ENGINEERING CHANGE NOTICE

Title: USB 2.0 Link Power Management Addendum
Applies to: Universal Serial Bus Specification, Revision 2.0

Summary of ECN

Figure 1-1. LPM State Transition Diagram

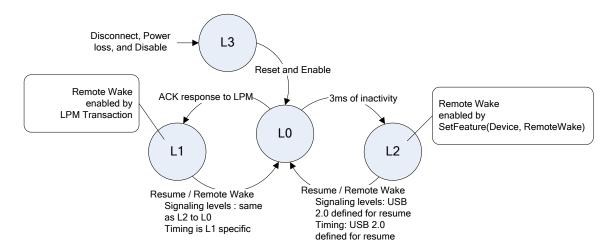
Figure 1-1 illustrates the allowed LPM state transitions. For example, a host must transition a link from L1 (Sleep) to L0 before transitioning it to L2 (Suspend), and similarly when transitioning from L2 to L1.

Figure 2-1. Packets in an Extension Token Transaction

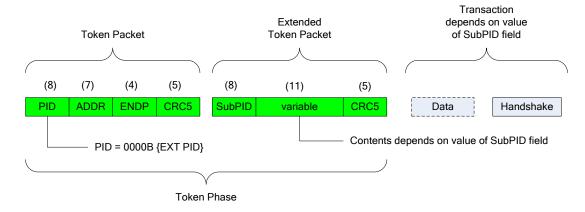
This addendum defines an extended token phase used to extend the USB transaction protocol. The token phase for an EXTended transaction is comprised of two token packets (each a standard 3 byte token packet), see Figure 2-1.

The first packet of an extension transaction is a standard token packet with EXT in the PID field, including: ADDR, ENDP and CRC5 fields. The EXT PID indicates that the next packet (with standard, back-to-back interpacket timing) is an extended token packet.

Figure 4-1. Port Control Model for Transitioning a Port to L1

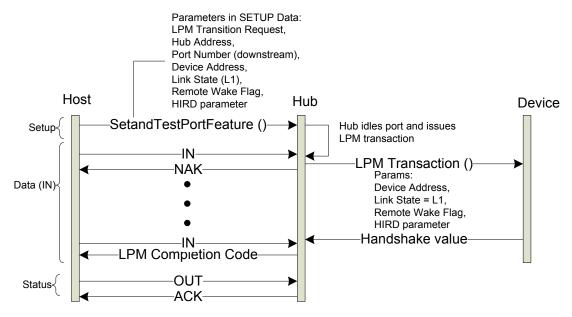
The operational control model for placing a port into L1 is similar to placing a port into L2 (Suspend), i.e. a command is sent via the Default Control Pipe to the hub, requesting it to transition a specific port to L1. A new SET and TEST control read transfer is used for this command. The operational command is fully contained in the SETUP stage and the DATA stage is used to return a completion code for the command. On receipt of the SETUP stage of the request to transition a port to L1, the hub begins NAKing the data stage transaction and *quickly* services the command. When the command is complete, it returns a completion code in the DATA stage and the host will complete the transfer with the STATUS stage. The details of this command are provided in Section 4.10.1. The port control model is illustrated in Figure 4-1.

If the designated port is in the proper state (i.e. enabled) when the request to transition to L1 is received, the hub first stops repeating traffic down the port by the next micro-frame boundary (after the SETUP stage was received) and issues an LPM transaction to the device (independent of the traffic which may be occurring on the other ports). When the LPM transaction completes the hub evaluates the results of the transaction to determine what to do with the port and what completion code to return to the host. If the device responds with an ACK, the port is placed into the L1 state and a SUCCESS completion code is sent back to the host. If the device responds with a NYET, the port is returned to the enabled state (restore normal operation) and a completion code of NYET is sent back to the host. If the hub gets a transaction error (including timeout), it must retry the LPM transaction two more times. If there are three consecutive errors then the port is returned to the enabled state and an error completion code (see Section 4.10.3) is sent back to the host.

Figure 4-3. Device Initiated L1 to L0 Transition (Remote Wake)

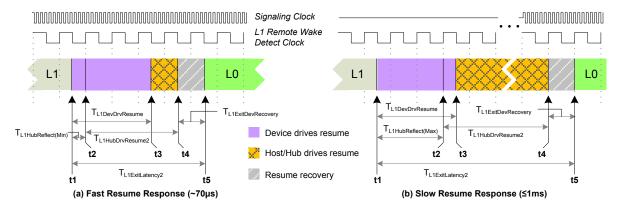
Figure 4-3 illustrates a device initiated resume (also called Remote Wake). A device initiating L1 exit must drive resume signaling for nominally $T_{L1DevDrvResume}$ [t1 \rightarrow t3]. The host must detect the resume signaling and reflect it (i.e. drive resume signaling on its corresponding port) within $T_{L1HubReflect}$ [t1 \rightarrow t2]. The host must drive resume signaling for a minimum of $T_{L1HubDrvResume2}$ [t2 \rightarrow t4]. This ensures that it drives resume signaling long enough for the device to stop driving resume, turn its receiver on and be ready to detect the end of resume signaling (i.e. speed appropriate EOP) [t3 \rightarrow t4]. From here on the process is identical to the host-initiated L1 to L0 described above.

Figure 4-3 illustrates two general scenarios that depict the timings based on the state of the host/hub's signaling clock (i.e. active or not active) at the time the device initiates remote wake. In Figure 4-3(a), the host/hub's signaling clock is active at the time it receives the remote wake signaling on the port in L1. In this case, the total time from remote wake to L0 ($T_{L1ExitLatency2}$) [t1 \rightarrow t5] is very fast because the host/hub can detect the resume very quickly ($T_{L1HubReflect(Min)}$) and is not constrained by the need to restart its signaling clock before transmitting

end of resume. In Figure 4-3(b), the host/hub's signaling clock is not running at the time it receives the remote wake, so the host/hub uses a much slower clock to detect remote wake and to reflect (begin driving) resume signaling down the port ($T_{L1HubReflect(Max)}$). Note that the host/hub must begin driving resume before the device stops driving remote wake (these are the same line state). This means the host/hub must detect and drive resume within $T_{L1HubReflect(Max)}$ of when the device asserted remote wake (this ensures the host is driving resume before the device releases remote wake, with a $1\mu s$ guard band). The host/hub needs to have its signaling clock stable in order to properly signal end-of-resume, and it may take some time to get it restarted and stable. The host/hub must complete resume signaling $[t2\rightarrow t4]$ before $T_{L1HubDrvResume2(Max)}$ elapses.

Figure 4-4. Example Remote-wakeup L1 Exit with Full-speed Device Under Connected Hub

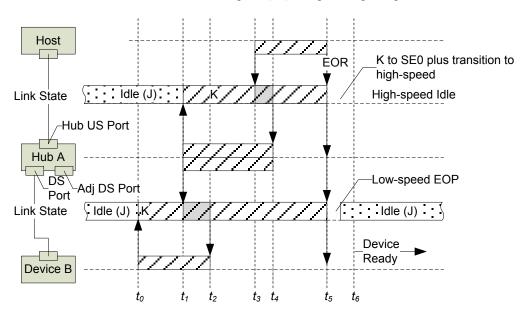
Figure 4-4 illustrates the timing relationships for an example remote wake L1 exit sequence. This example is almost identical to a remote wake from suspend (L2) except the signaling event durations are much shorter.

At [t0] the full-speed device drives a K on its upstream port, initiating the L1 Exit (remote wake). The duration of the device driving K is [t_0 to t_2] ($T_{L1DevDrvResume}$). At t_1 the hub upstream of the device begins driving K on the link, so between t1 and t2 both the device and the hub are driving on the link between Device B and Hub A. At the same time [t_1] the Hub also begins driving a K on its upstream link and continues to drive K (upstream and downstream) until t_4 (duration is also $T_{L1DevDrvResume}$). At t_3 the host upstream of the hub begins driving K on the link, so between t_3 and t_4 both the hub and the host are driving K on the link between Hub A and the Host. The Host drives K downstream until t_5 at which time it drives a speed-appropriate EOR (end of resume) on the link between the Host and Hub A (which includes a transition to high-speed mode). Hub A repeats the K to SE0 transition (at t_5) and times two Low-speed bit times of SE0 and then drives a J on the link between Hub A and Device B. The Host waits until after t_6 to issue a transaction to Device B.

Figure 4-6. Host Initiated L1 to L0 Transition (L1 Exit)

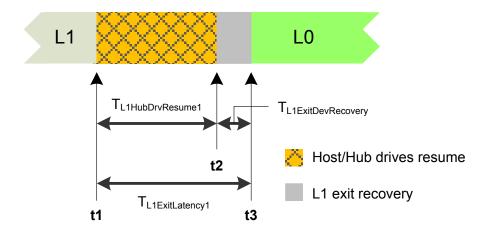
Host initiated resume signaling from L1 to L0 is illustrated in Figure 4-6.

A host initiating L1 exit drives resume signaling for a minimum of $T_{L1ExitHostDrvResume1(min)}$ [t1 \rightarrow t2] and provides at least $T_{L1ExitDevRecovery}$ [t2 \rightarrow t3] of resume recovery time between the end of resume signaling (EOP) and transmittal of the first transaction that targets the resumed device. The duration of the resume signaling is specified by the host in a parameter called the HIRD (Host Initiated Resume Duration) and is in the range between $T_{L1HubDrvResume1(min)}$ and $T_{L1HubDriveResume1(max)}$. The total L1 exit latency expected from a host initiated L1 exit is the range of $T_{L1ExitLantency1}$ [t1 \rightarrow t3].

Figure 4-7. USB 2.0 Hub Reference Port State Machine Relationships with L1 Additions

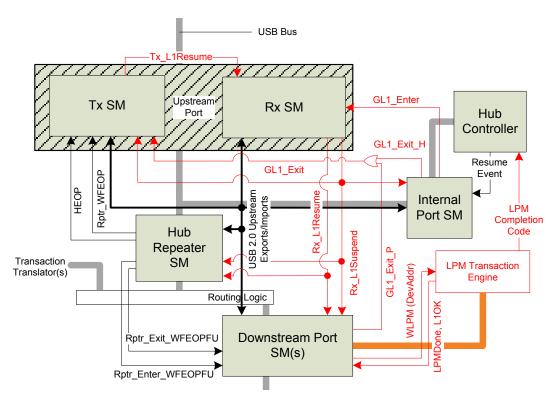
There are three reference ports (control points) in a hub which together with the Hub Repeater and Hub Controller comprise the functional operation of a hub. Figure 4-7 illustrates the documented inter-state machine signals between the different reference port state machines that exist inside of a USB 2.0 Hub, with the necessary extensions required to support L1. The inter-state machine signals used in USB 2.0 are documented. The USB2.0 suspend/resume relevant signals are 'highlighted' bold line. The colored lines and boxes illustrate the extensions necessary to support L1.

A new element for L1 support is for each port there is an LPM Transaction Engine (LPM TE). The purpose of this new element is described in Section 4.8.1.

Figure 4-8. L1 Addendum to the Upstream Facing Port Receiver State Machine

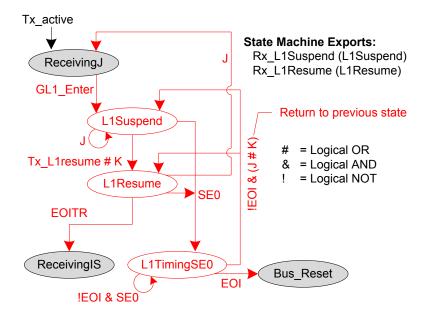
Figure 4-8 illustrates the additions to the upstream port receiver state machine to support L1.

Figure 4-11. Addendum to Downstream Facing Hub Port State Machine

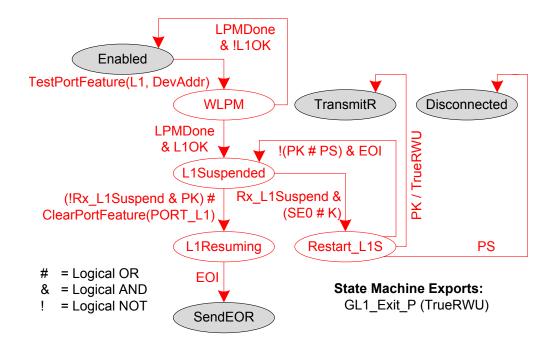
The downstream port state machine controls the behavior of each downstream port. There reference model provides for one downstream port state machine instance for each port. Figure 4-11 illustrates the additional states in downstream port state machine to support L1.
